KMR.CDD.JmQ.1933.04

KARACHI MUNICIPALITY.

Case No. P/O 321/33

PLAN FOR PROPOSED BUNGALOW ON

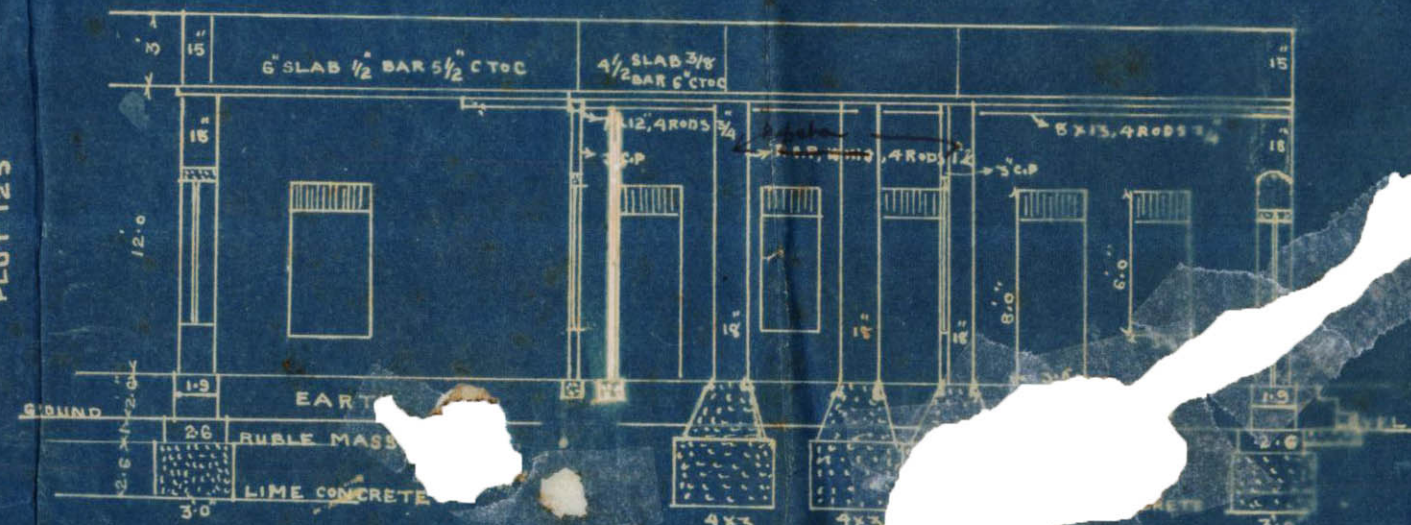
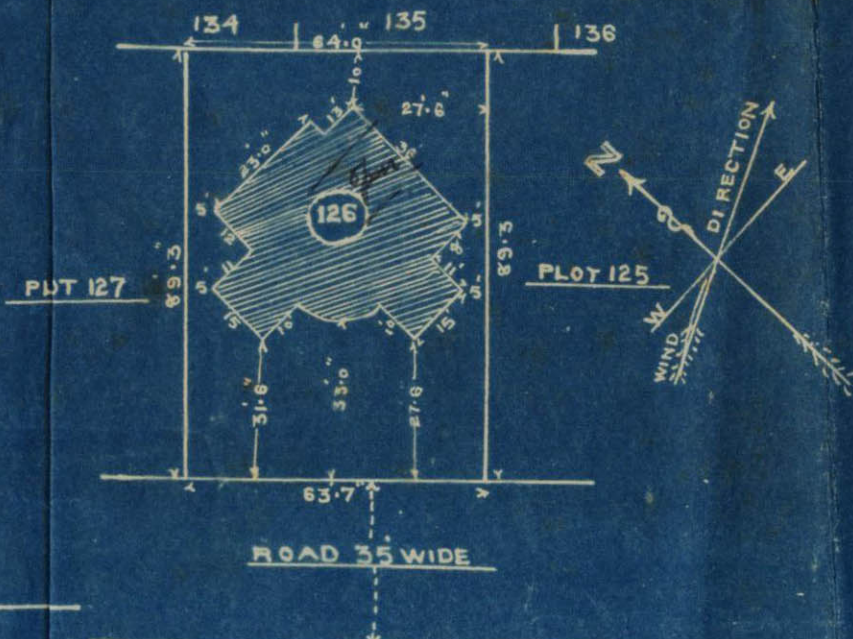
1. External walls must be Pucca or 6" C.C.
2. Sizes of *square* columns must be specified.
3. Passage to W.C. must have a window.

All external walls are made
6" C.C.

(2) sizes of pillars are $4' \times 1\frac{1}{2}'$, $4' \times 1\frac{1}{2}'$
+ $2' \times 1\frac{1}{2}'$.

(3) window has been provided.
